SUBJECT: Supplements 790102 responses to NRC 781127 ltr re fire protection. W/encl schedule for fire protection activities.

Re: Nine Mile Point Unit 1  
Docket No. 50-220  
DPR-63

On January 2, 1979, we provided a partial response to your November 27, 1978 letter regarding fire protection at Nine Mile Point Unit 1. The enclosed information provides the remaining responses. Those responses that have been modified are indicated by a line in the margin.

FIGURE III - 12

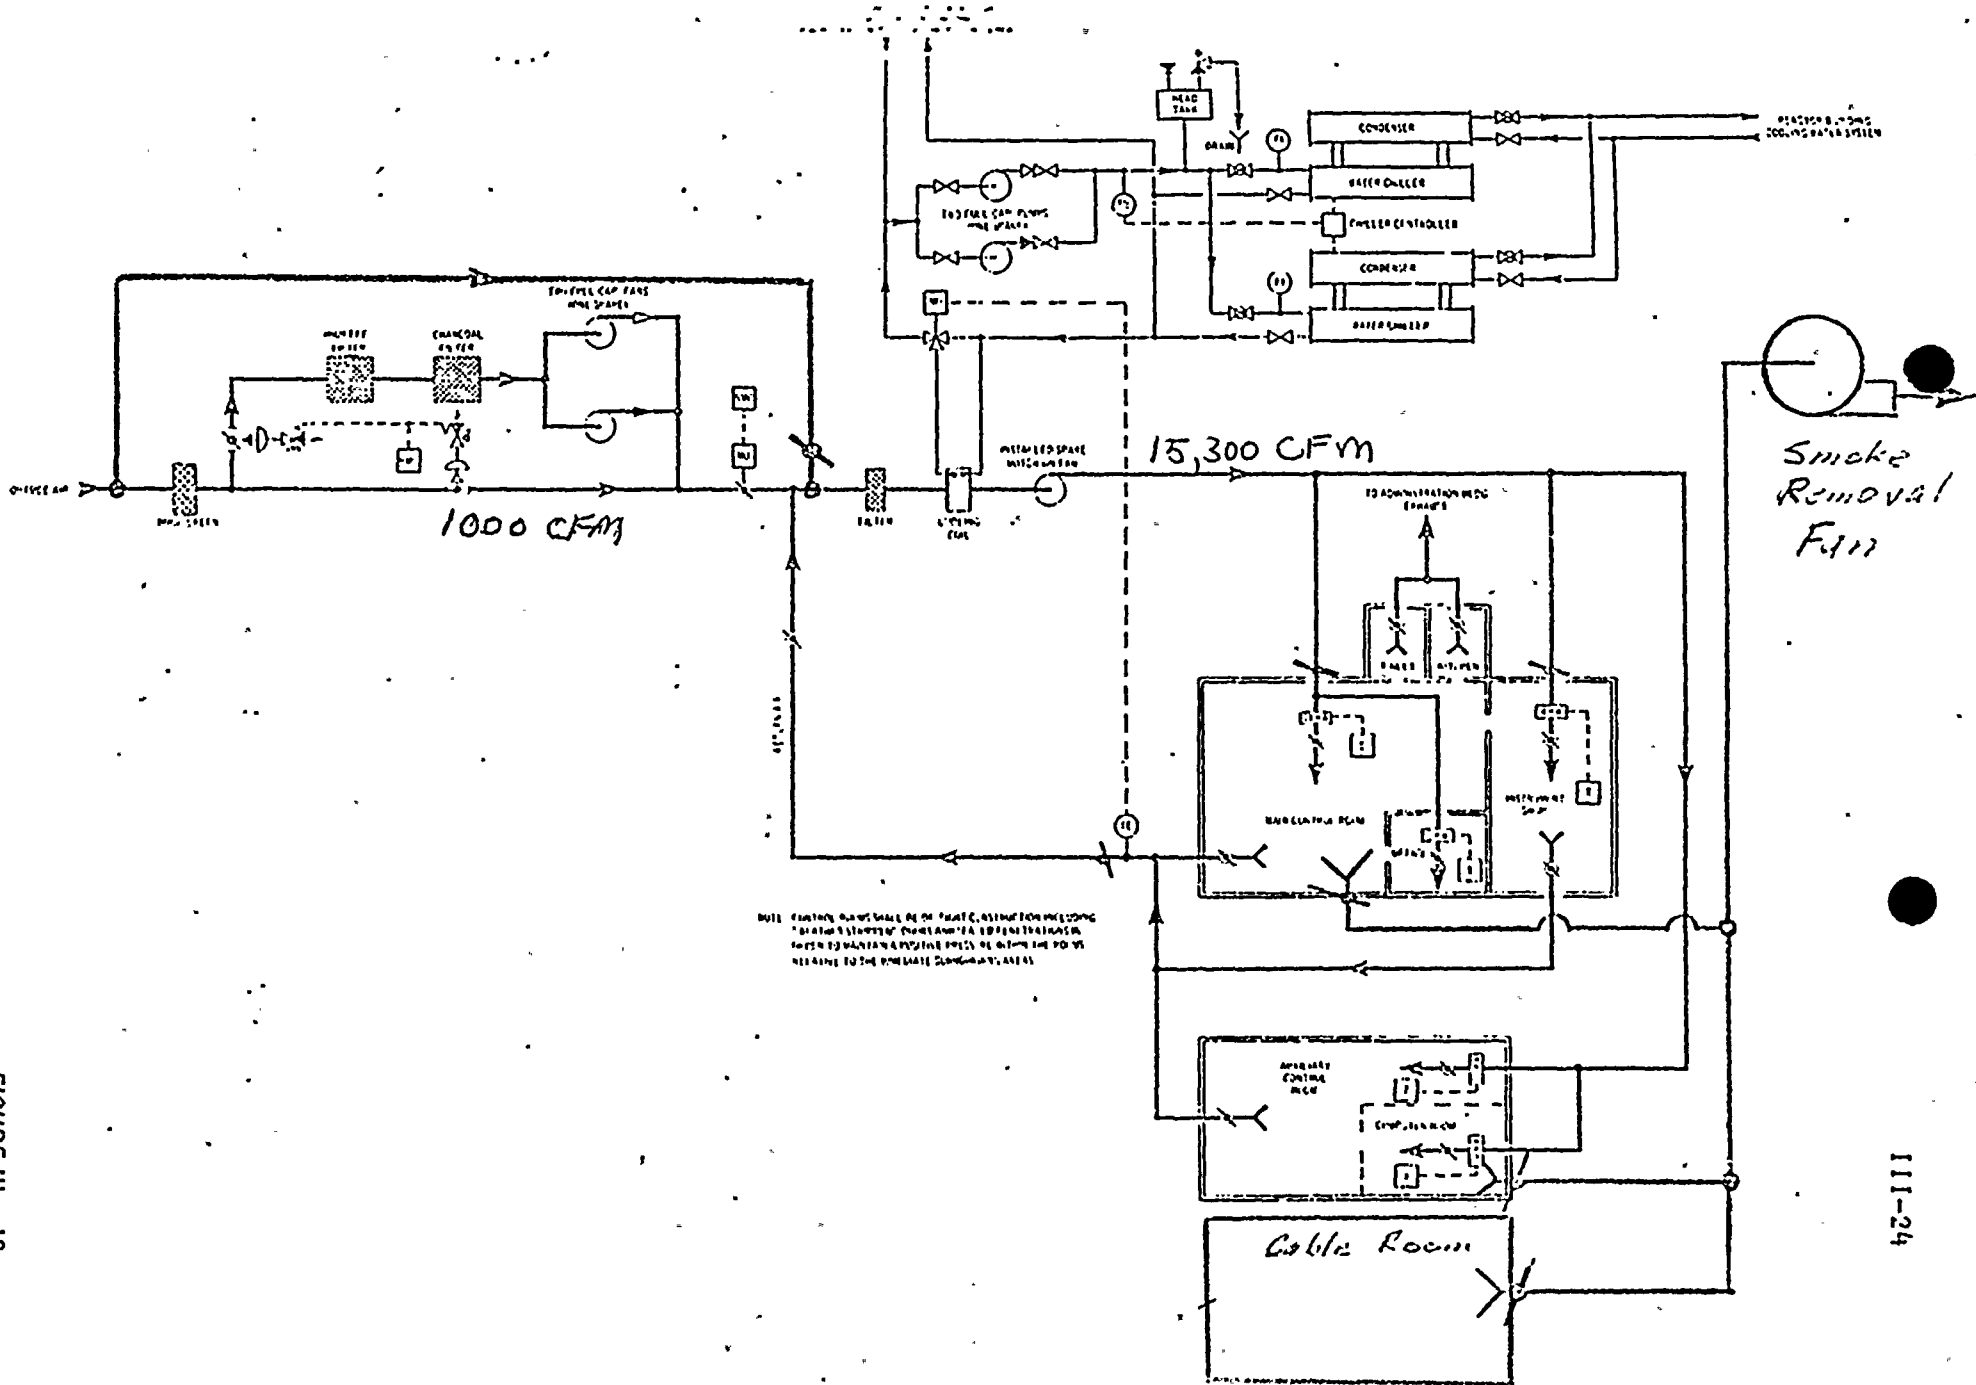
Detail the proposed modification to the HVAC system necessitated by your planned modification to the auxiliary control room - control room interface (which provides a CO<sub>2</sub> seal to the auxiliary control room). Verify that the HVAC system modification meets the requirements of Regulatory Guides 1.78 and 1.95, to the maximum extent that is practical.

The existing ventilation system recirculates 15,300 CFM of air and provides 1000 CFM of new air. This design is not sufficient to evacuate smoke efficiently.

A 100% fresh air input and exhaust will be provided. The following modifications will be made:

1. Addition of new supply and exhaust ducts
2. Smoke exhaust fan
3. Additional dampers

The items above are shown on the attached figure. The new system is designed for emergency use. The system function will be to evacuate smoke during a control room fire. During normal operation the presently installed ventilation system will be used.

The present system has been analyzed and meets Regulatory Guides 1.78 and 1.95. The new system is used when the control room is uninhabitable due to smoke. Therefore, Regulatory Guides 1.78 and 1.95 are not applicable to the new system.
